**Name:** Gerhard Botha  
**Cell:** 084 207 3454  
**E-mail:** gerhard@nkurenkuru.co.za  
**Date:** 14 April 2022  
**Ref:** Lichtenburg 1 PV Part 2 Amendment

**ECOLOGICAL AND AQUATIC/WETLAND COMMENTS: PROPOSED AMENDMENT TO THE AUTHORISED ABO WIND LICHTENBURG 2 PV PROJECT (DEA REF 14/12/16/3/3/2/1091).**

Figure 2: Google Image™ illustrating the “now” preferred grid route (portion of Grid Connection Alternative 2) and a slightly smaller on-site substation footprint (now only 900m<sup>2</sup>).

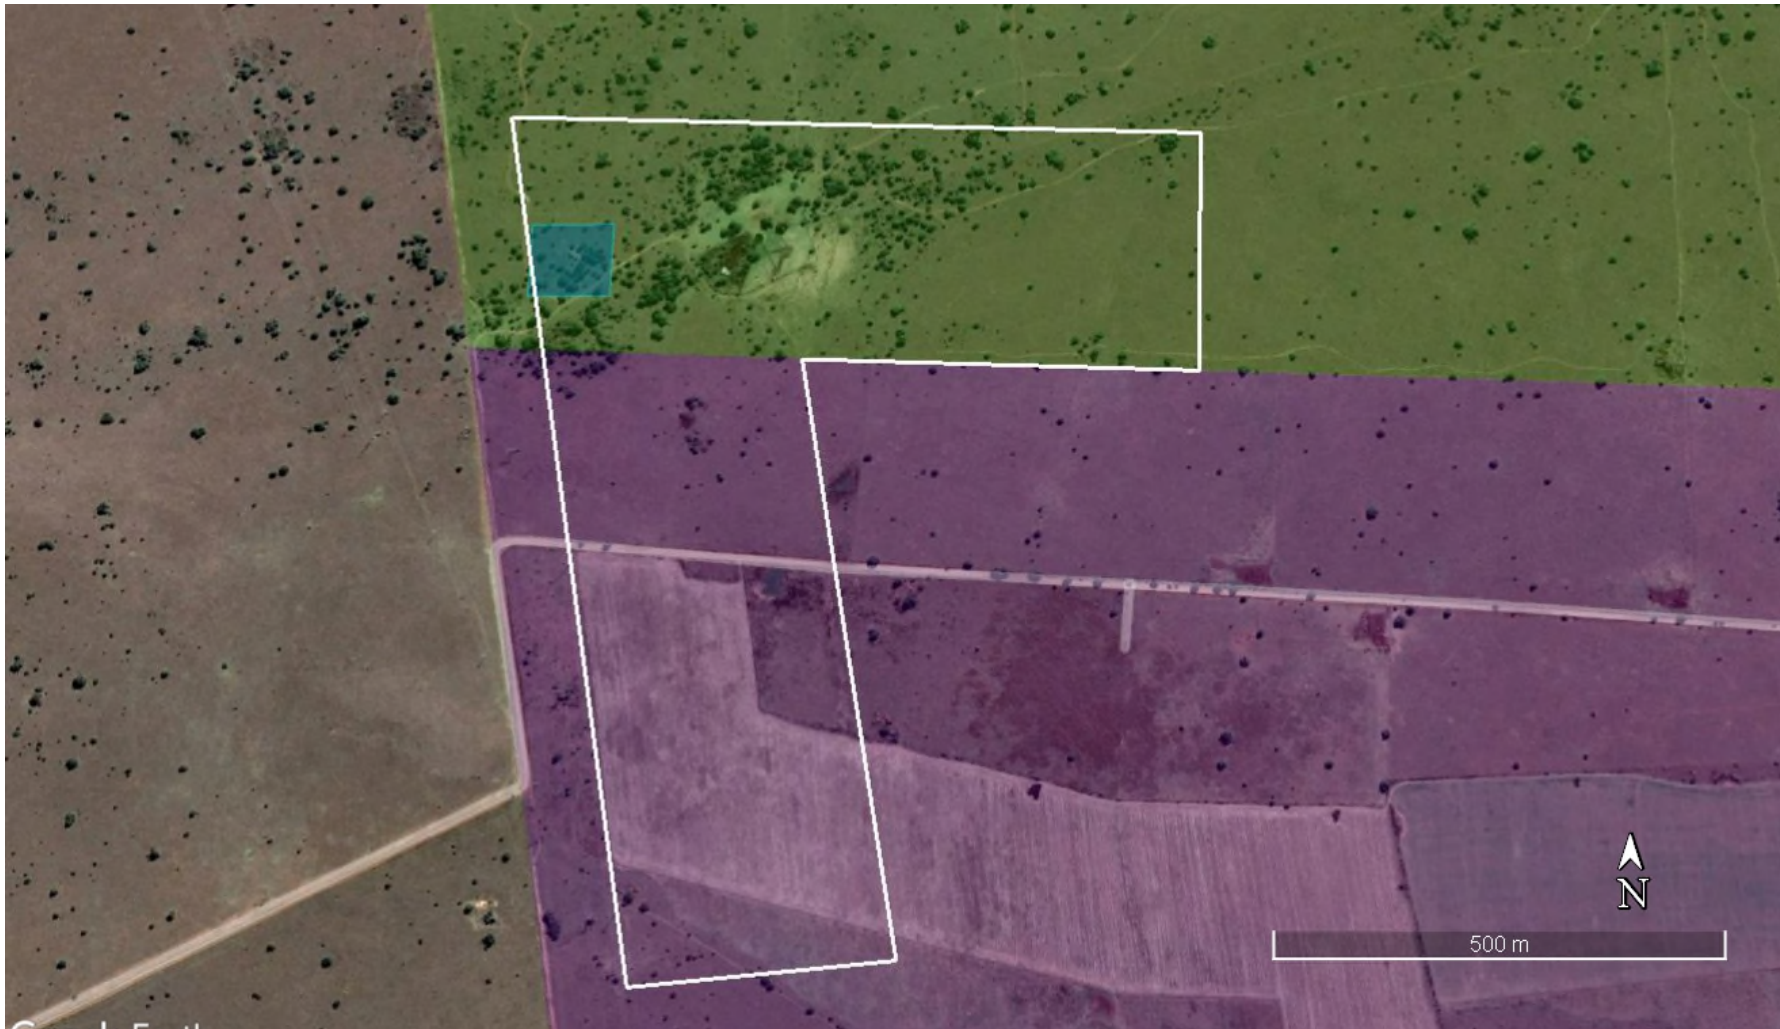
ABO Wind Lichtenburg 1 PV (Pty) Ltd is now considering a part of the assessed Grid Connection Alternative 2 corridor as the preferred corridor in the EA<sup>2</sup> for ABO Wind Lichtenburg 1 PV (hereinafter referred to as L1) (refer to Figure 2 and Figure 3). This will allow the project to connect to the proposed collector (on-site/step-up) substation complex of ABO Wind Lichtenburg 3 PV on the authorised footprint of Lichtenburg 3 PV.

Figure 3: Google Image™ comparing the two grid routes. Google Image on the left: Authorised grid route; Google Image on the right: Newly proposed grid route.

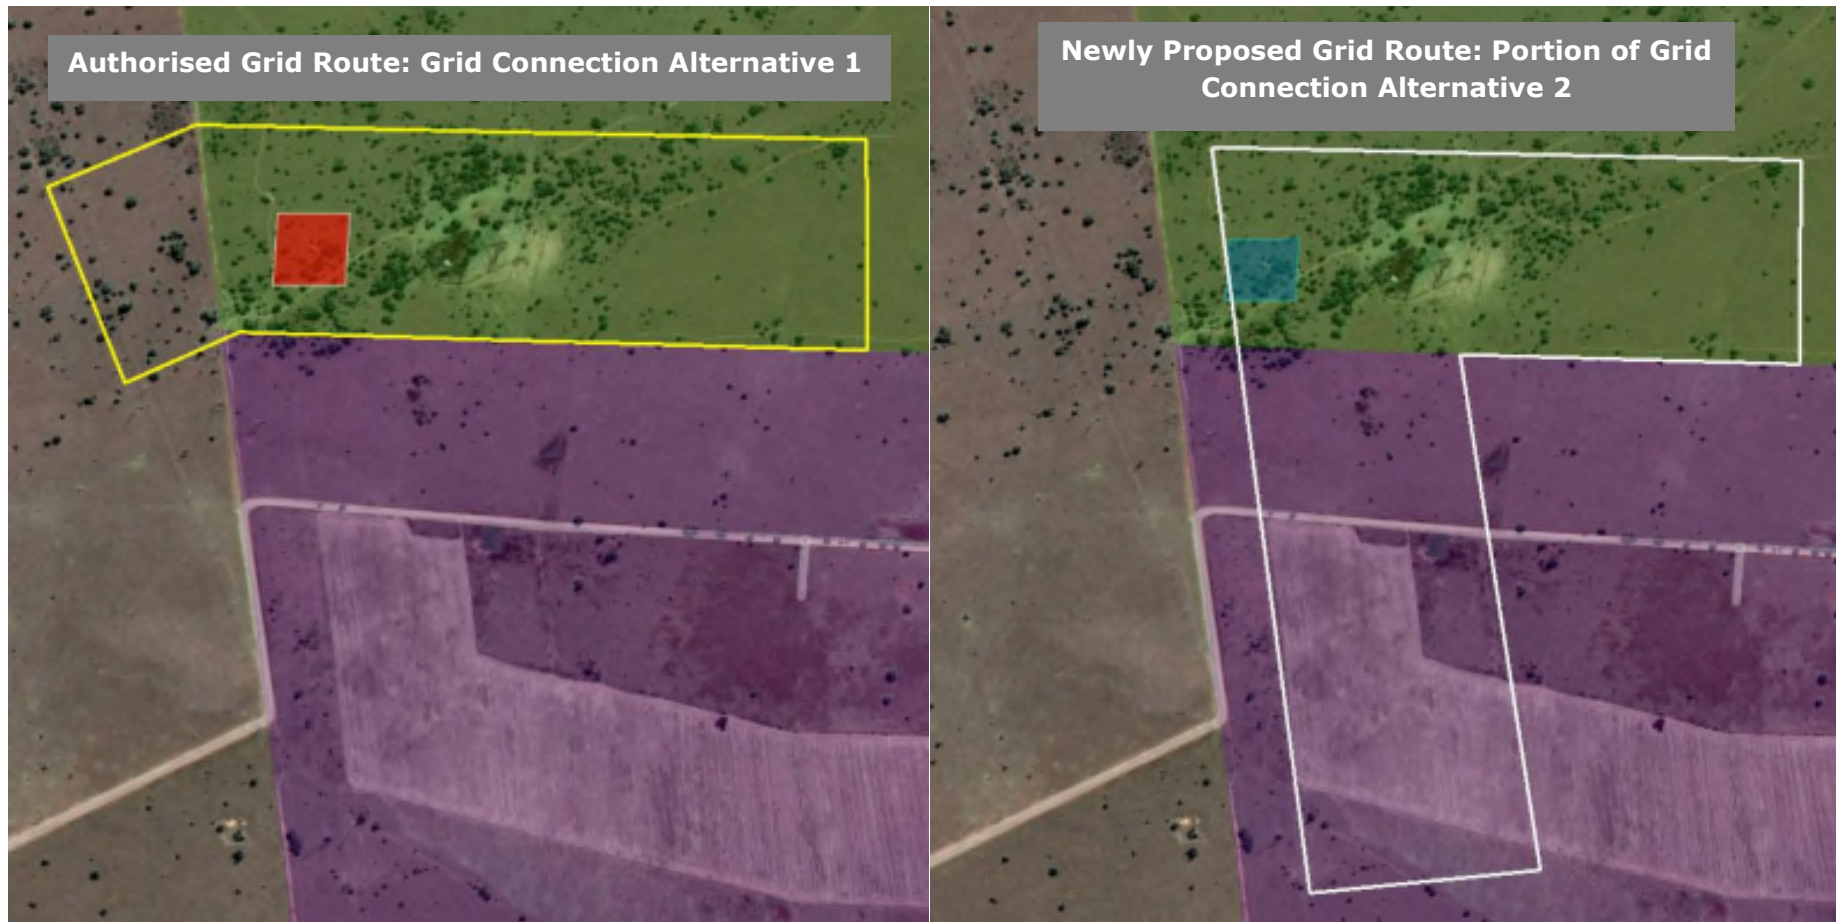
- » Even though, the newly proposed, preferred grid route will be slightly longer, the extent of the additional area as well as the present ecological condition/status of this additional area is of such a nature (small additional area, traversing mainly transformed areas), that a change in the significance of all assessed impacts is not warranted
- » The same situation is applicable for the amendment to the on-site substation, where the amendment to the development footprint (slight reduction), is not significant enough to warrant any change in the significance of all assessed impacts.

- » Furthermore, the proposed amendments to the preferred grid corridor and the on-site substation footprint will not result in any additional impacts (impacts not mentioned or assessed within the “original” ecological impact assessment).
- » Subsequently the assessment of the impacts within the original report will remain unchanged and are still applicable.

- » Even though, the newly proposed, preferred grid route will be slightly longer, the extent of the additional area as well as the present ecological condition/status of this additional area is of such a nature (small additional area, traversing mainly transformed areas), that a change in the significance of all assessed impacts is not warranted

- » The same situation is applicable for the amendment to the on-site substation, where the amendment to the development footprint (slight reduction), is not significant enough to warrant any change in the significance of all assessed impacts.

Figure 4: Google Images™ comparing how land use practices and the ecological status may have changed over time (between 2018 and 2021). From the satellite images it is clear that now significant changes have occurred over time.

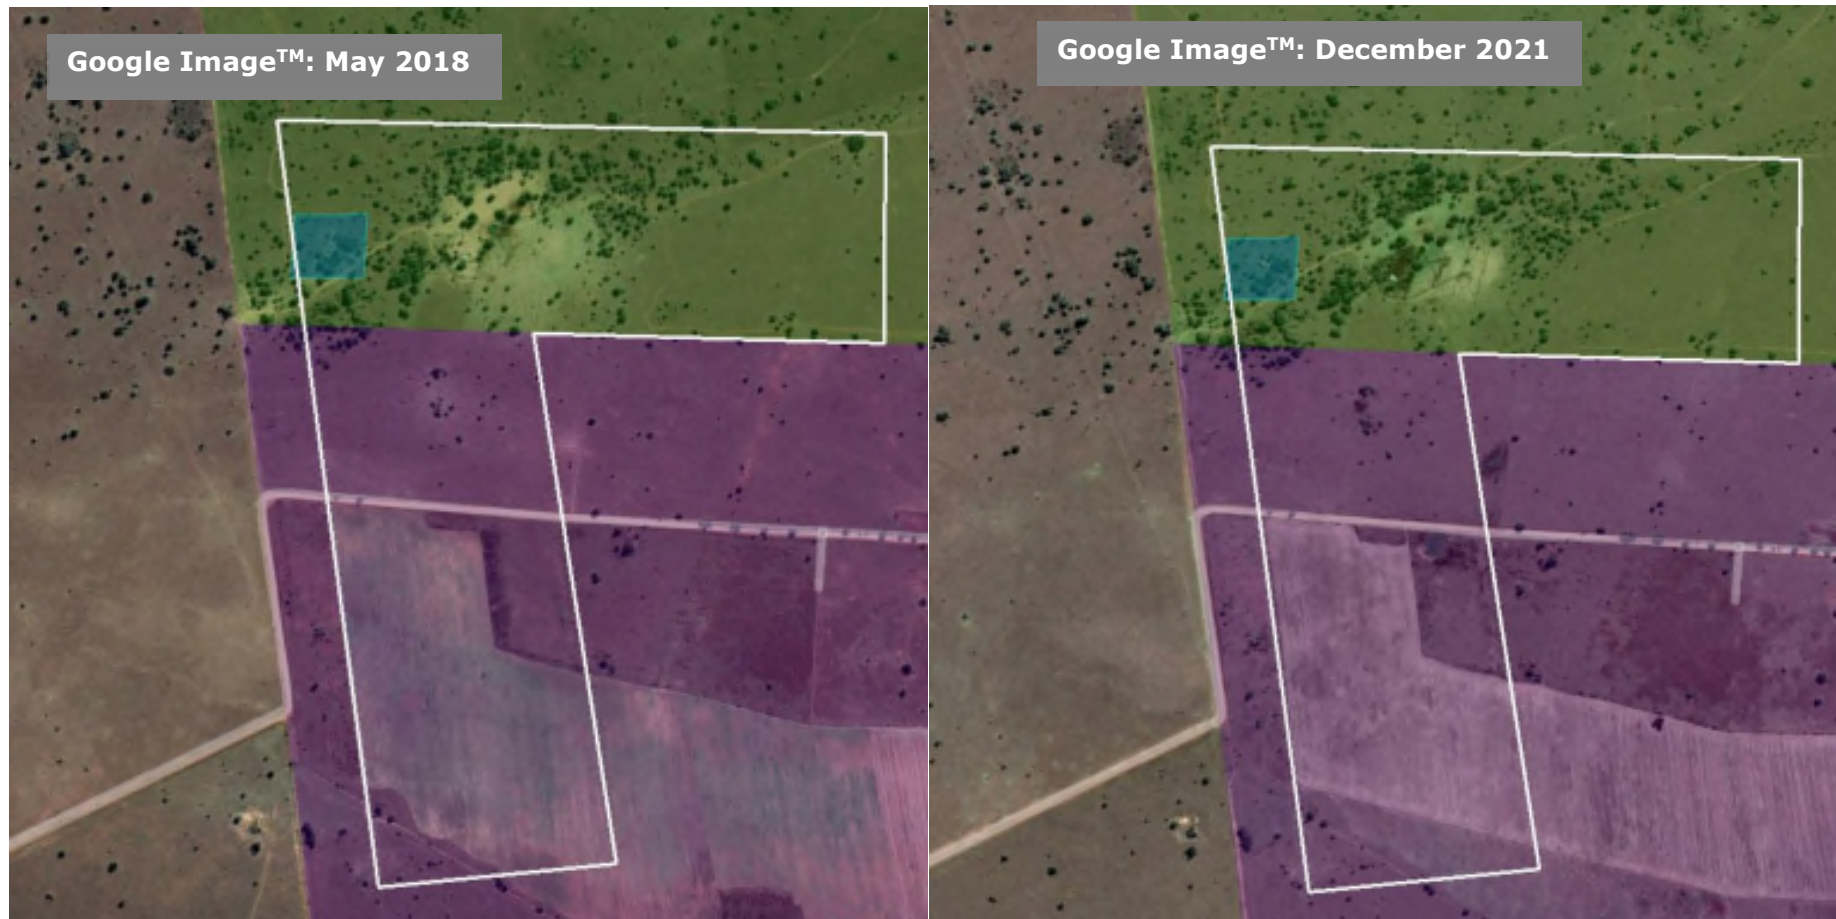
Based on a comparison between recent satellite images (Google Earth Satellite Image from December 2021) and satellite images used during the Ecological Assessment (Google Earth Image from May 2018), land-use practices remained the same (predominantly cattle grazing with a small area being cultivated to the south (within Portion 2 of Farm Zamenkomst No. 04)) with no clear change in vegetation structure and the present ecological status of the assessed area (Figure 4). As such the need for a site visit as part of the Part 2 Amendment was deemed unnecessary with the findings of the terrestrial and wetland/ecological study and assessment still regarded as applicable.

Figure 5: Maps indicating the land coverages and land uses characterizing the two grid routes. Image on the left: Authorised grid route; Image on the right: Newly proposed grid route.

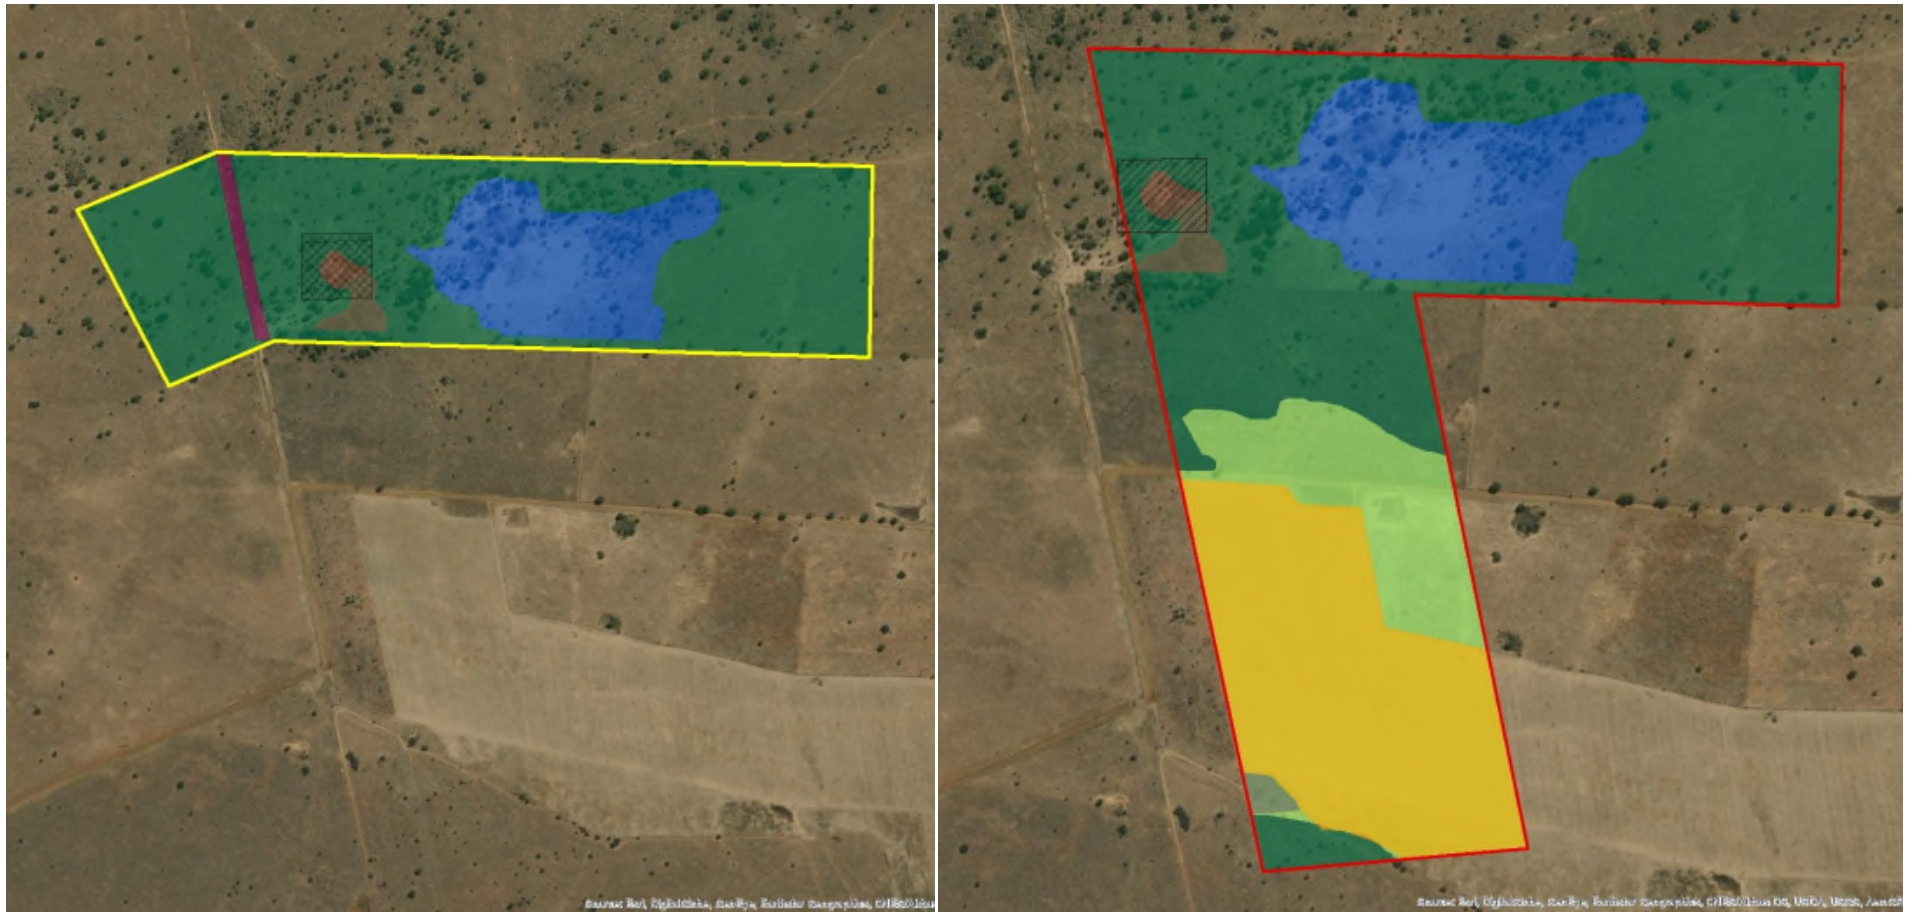
During the original ecological survey two vegetation associations were identified within the proposed grid corridors (Figure 5):

- » Association 1: *Elionurus muticus* – *Helichrysum callicomum* Savanna Grassland; and
- » Association 2: *Hyparrhenia hirta* – *Elionurus muticus* Grassland

Plant association 1 covers slightly deeper sand-loam soils which are regarded as high to moderately high arable lands and as such large portions of this association have been extensively ploughed. The bulk of the area is covered by plant association 2 which covers shallow, rocky soil forms. Furthermore, other forms of disturbances/land use within the grid corridors include kraals, artificial watering points and dirt roads (twin tracks). The authorised grid corridor and on-site substation will be solely located within plant association 1 whilst the newly proposed grid corridor will be mostly located within this association whilst the southern portion of the grid corridor will traverse a small portion of plant association 2 (of which most have been transformed through cultivation practices).

Figure 6: Maps indicating the ecological sensitivity within the two grid routes. Image on the left: Authorised grid route; Image on the right: Newly proposed grid route.

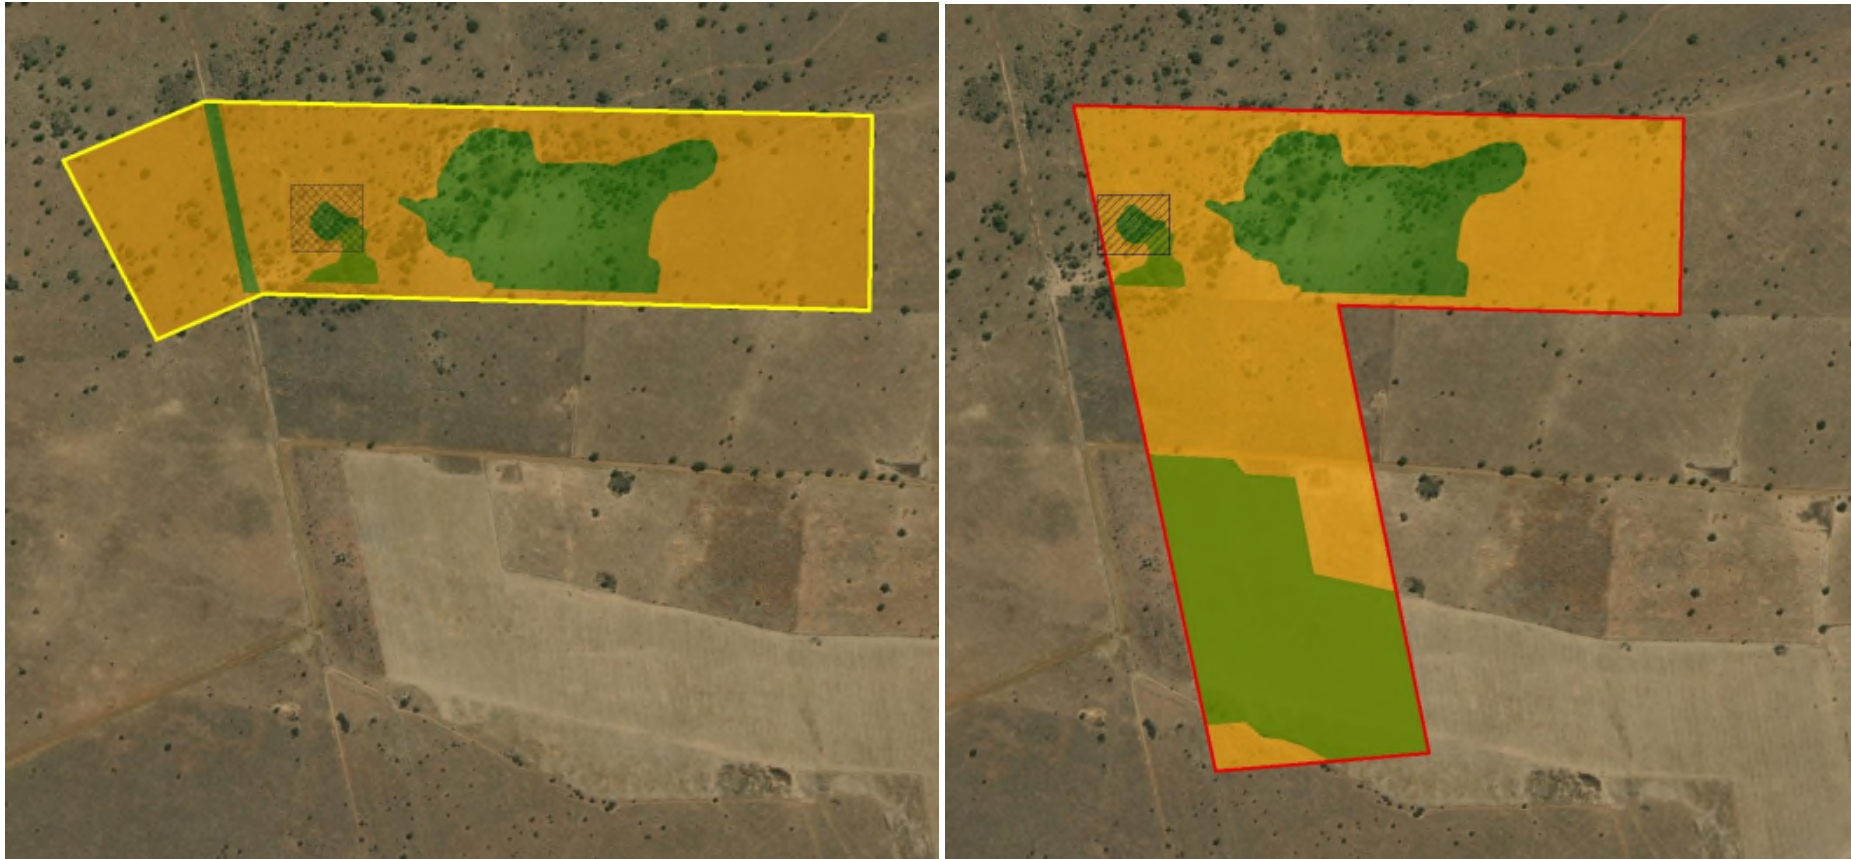
According to the sensitivity assessment, both of these vegetation associations have been classified as **medium sensitivity** (Figure 6). All disturbed and transformed areas have been furthermore, classified as **low sensitivity**. During the Ecological Study and Assessment, it was found that both of these vegetation associates were regarded as **acceptable for the proposed grid infrastructure development**.
